S.B. N° 133
Page 2 of 2

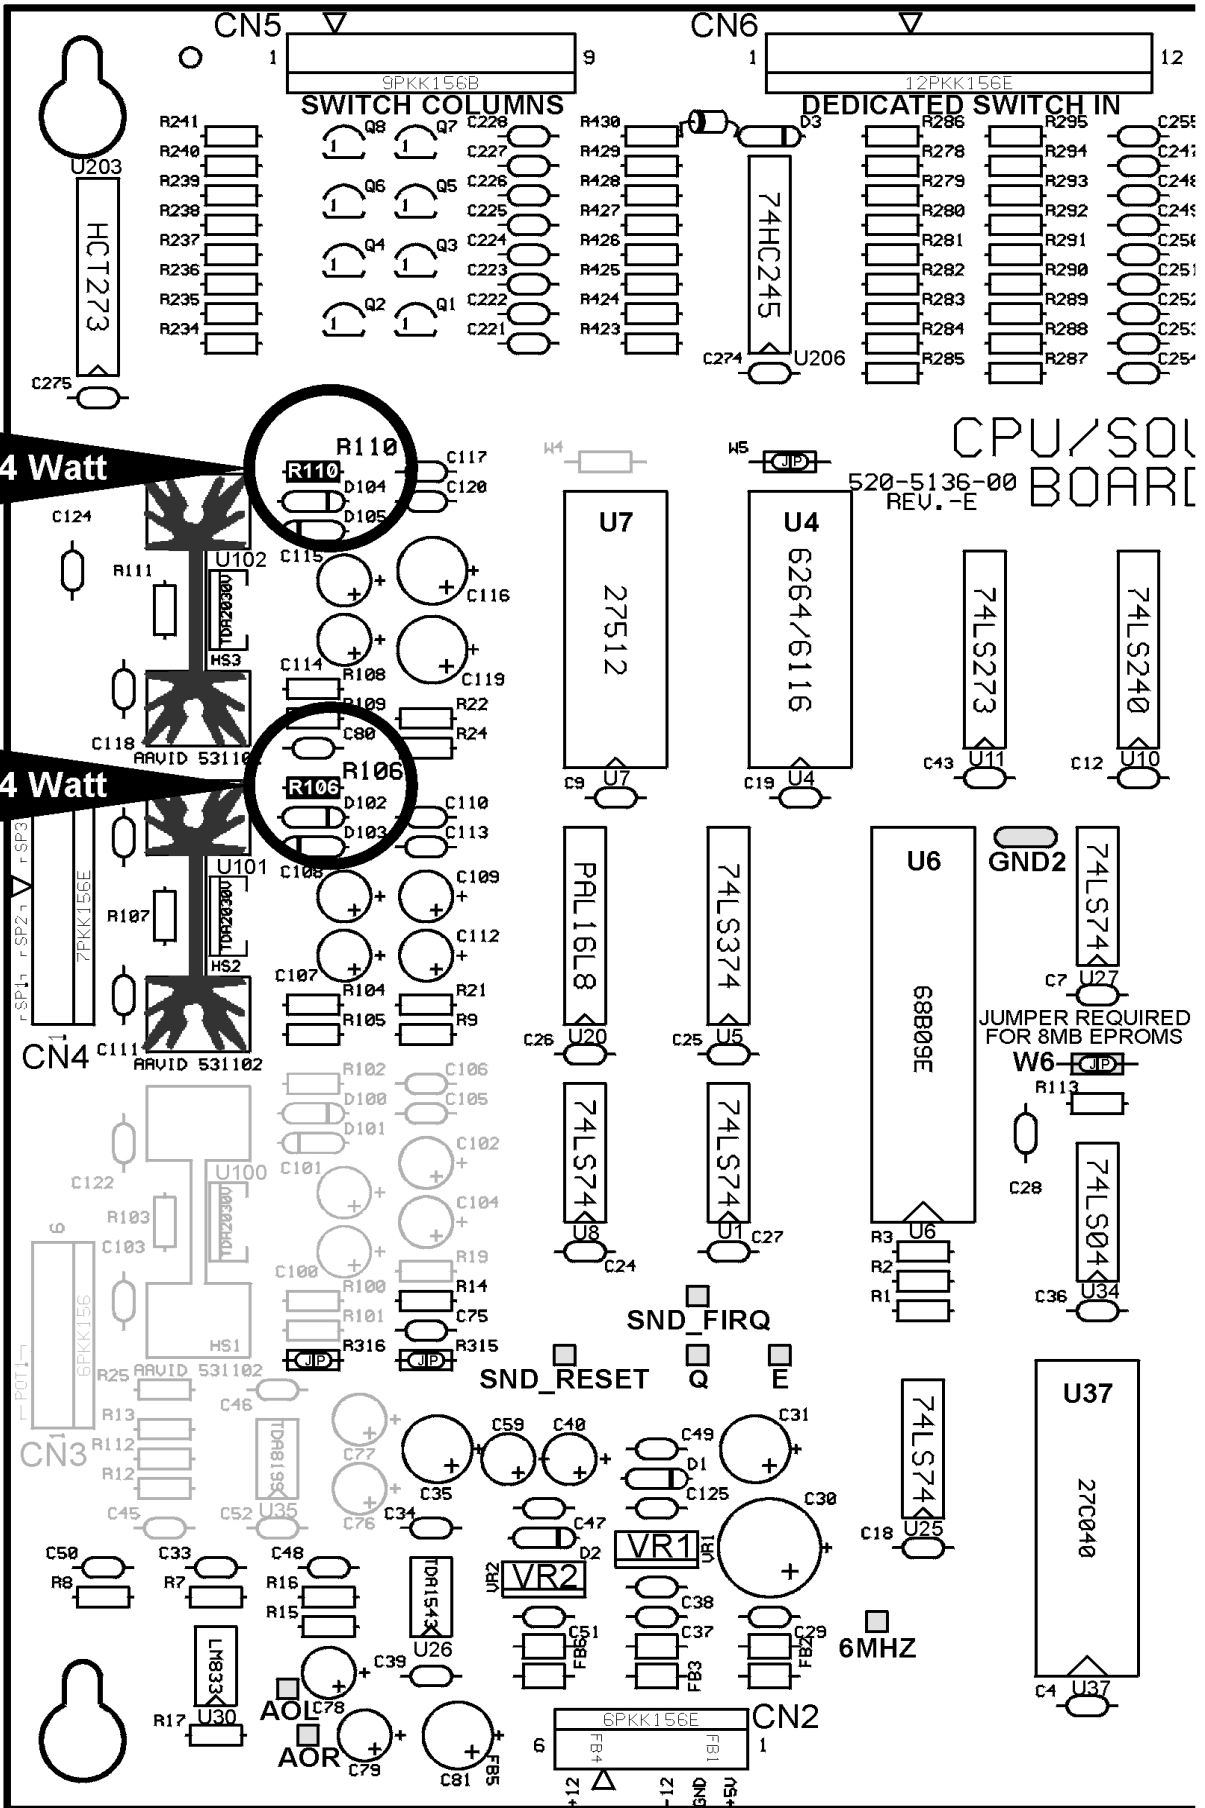
Change
R110 to:

Change
R106 to:

Resistor
33K Ω 1/4 Watt

Color Code:
ORG-ORG-ORG-GOLD

Resistor
10K Ω 1/4 Watt

Color Code:
BRN-BLK-ORG-GOLD
